HORSHAM DISTRICT COUNCIL CONSULTATION

TO:	Horsham District Council – Planning Dept
LOCATION:	Former Novartis Site Parsonage Road Horsham West Sussex
DESCRIPTION:	Residential development comprising approximately 206 dwellings, including the conversion of 'Building 3' and demolition of 'Building 36'. Vehicular access taken from Wimblehurst Road. Car and cycle parking, landscaping and open space and associated works. The replacement of the existing cedar trees at the site.
REFERENCE:	DC/25/0629
RECOMMENDATION:	Advice / more information / modification
2nd response in Red	Holding objection to RPA concerns that have not been addressed or appropriately justified and additional RPA concerns with proposed drainage infrastructure /more information / modification
SUMMARY OF COMMENTS & RECOMMENDATION: The application seeks planning consent for a mixed residential-led redevelopment of the former Novartis site. The submitted Arboricultural Impact Assessment (AIA) identifies 30+ individual trees and several hedgerows for removal, primarily due to direct conflicts with the proposed layout or limited remaining life expectancy. While several trees are to be retained and protected throughout constru

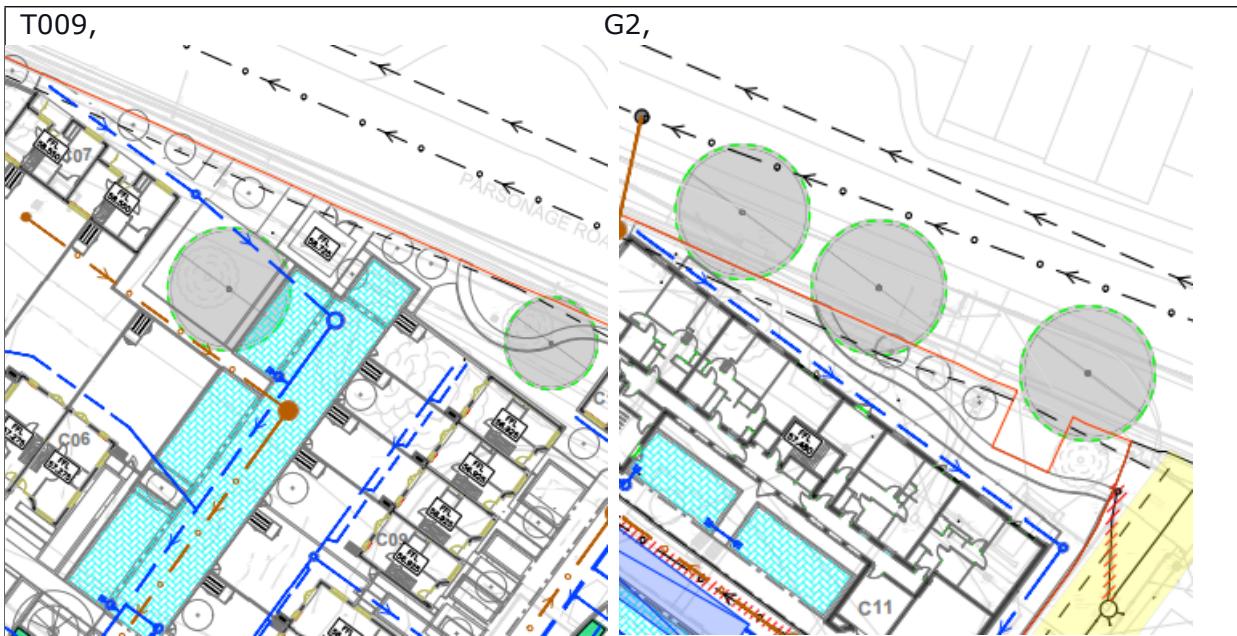
T002, T006, T007: Outbuildings erected using "no-dig" or base-and-beam foundations. The outbuildings, such as bike stores, should be moved and kept outside of the RPAs. **The bike stores still appear to be shown within the RPAs of trees T002, T006, and T007. Given the trees' visually prominent roadside locations and high landscape value, the bike stores should be relocated outside of the RPAs. Modification is required**
